Proposal for Supplement 1 to UN Regulation No. 170 (Child Restraint Systems for Safer Transport of Children in Buses and Coaches)

Submitted by the Informal Working Group on Safe Transport of Children in Buses *

The text reproduced below has been prepared by the Informal Working Group on the Safe Transport of Children in Buses to align the text of the UN Regulations covering adult and child safety. The modifications to the current text of the UN Regulation are marked in bold for new or strikethrough for deleted characters.

Figure 1 Labels for a Forward- and a Rearward-Facing Child Restraint System

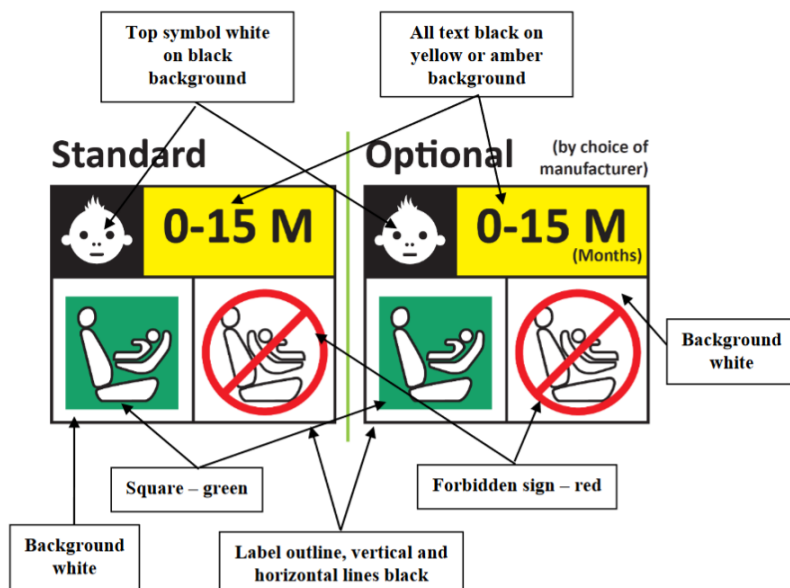
"5.2. Integral Child Restraint Systems that can be used forward and rearward facing, shall have the following label permanently attached on the part hosting the child and visible to the person installing the Child **Restraint System**:

The manufacturer shall be permitted to include the word "months" to explain the symbol "M" in the label. The word "months" should be in a language commonly spoken in the country ~~or countries~~ where the vehicle with the Child Restraint System is registered. More than one language is allowed.

Figure 13
Strapped-in Child

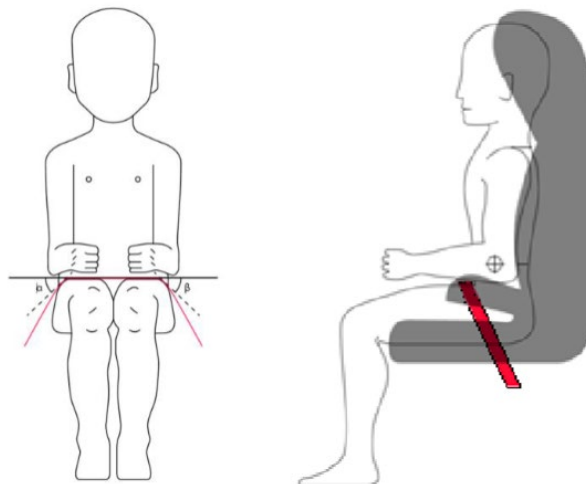
In the case of non-integral Child restraint Systems, the lap portion of the adult safety-belt shall be positively guided on both sides to ensure that the loads transmitted by the adult lap belt are transmitted through the pelvis. The positive guidance of loads over the pelvis shall be realized from the moment that the child is installed; the lap belt shall pass over the top of the thigh, just touching the fold with the pelvis. The angles α and β between the tangent line in which the belt touches the thighs and the horizontal shall be greater than 10° as show in in figure ~~4~~**3**.

Figure 24
Arrangement for Testing a Forward-Facing Device

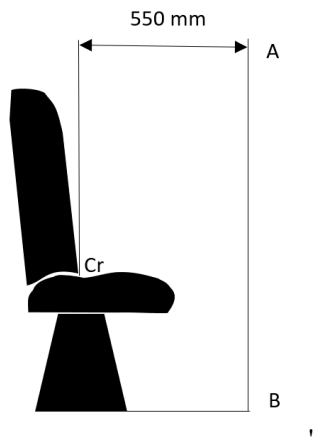
"8.3.6.6.1. No part of the head of the dummy shall pass beyond the planes BA as defined in Figure 24 below.

8.3.6.6.1.1. Where a test is conducted in accordance with paragraph 8.3.4.2. above, a tolerance of +10 per cent shall be applicable to the head excursion value distance between Cr point and plane AB.

Figure 35
Examples of Arm Alignment

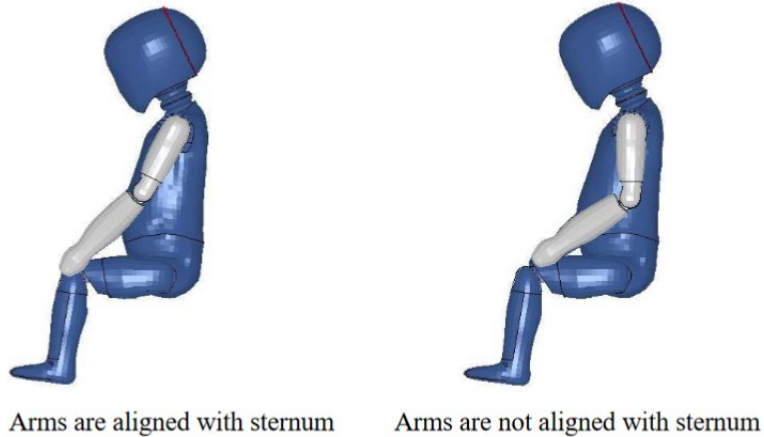
Example for arm alignment is show in in Figure 35:

Figure 2
Measurement Device for Child Restraint Systems – Side and Front View of the Measuring Device

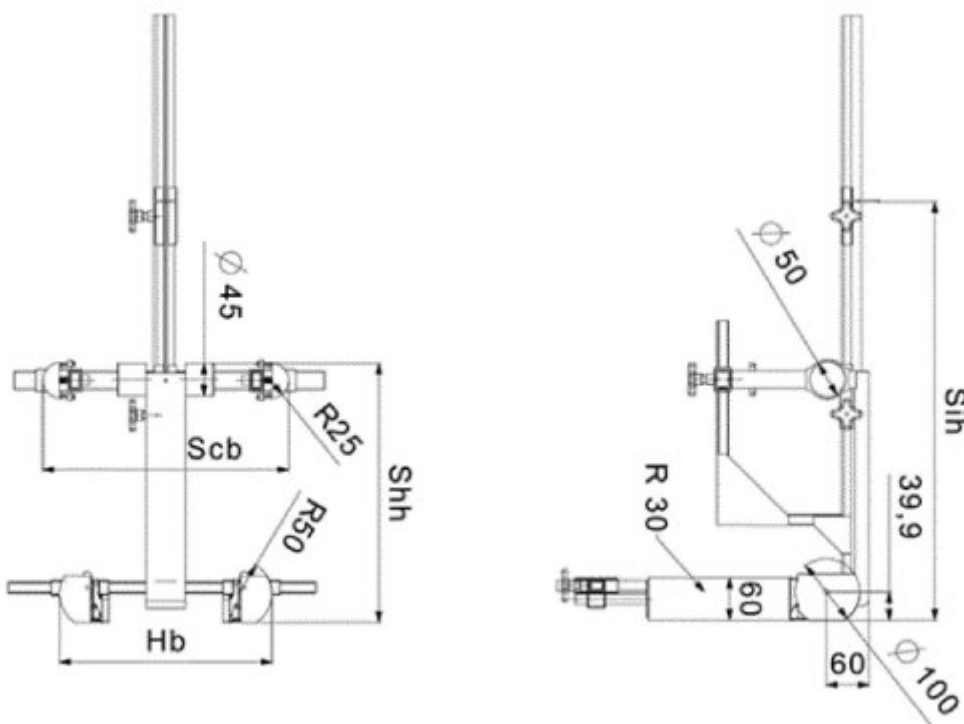
All lateral dimensions are measured under a contact force of 50 N with the devices described in Figure 2 and Figure 3 of this annex and the following tolerances will applied:

The mass of the devices described in Figure 2 and Figure 3 of this annex shall be 10 kg ± +/- 1 kg.

"Example 2

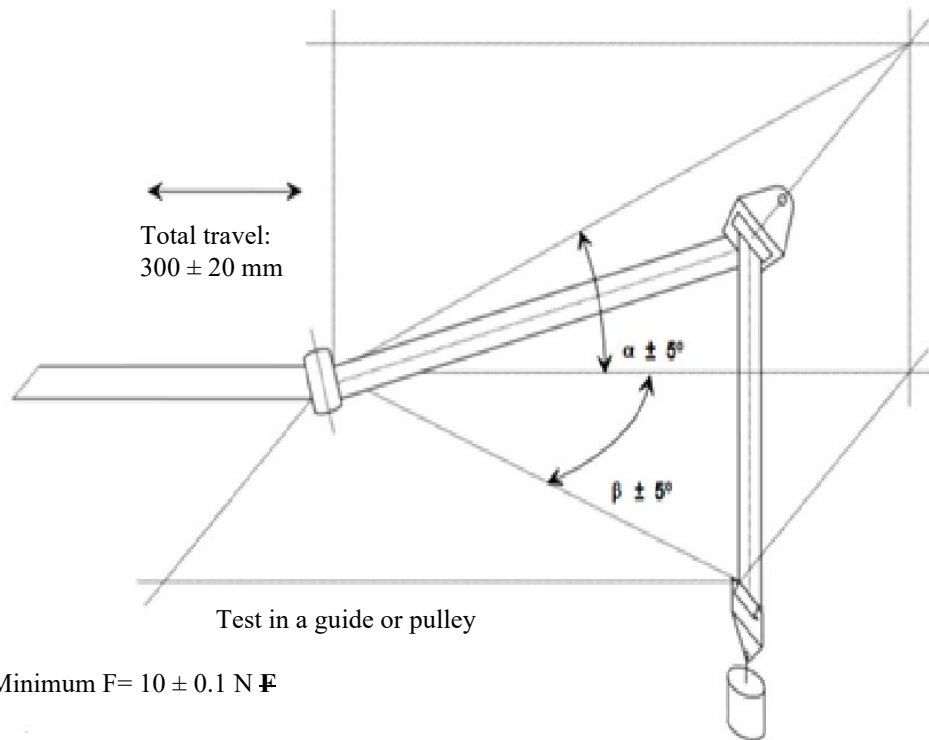
Annex 10, Figure 2, Example 2, amend to read:

Where α and β reproduce the angles as in the real installation (in the three dimensions)"
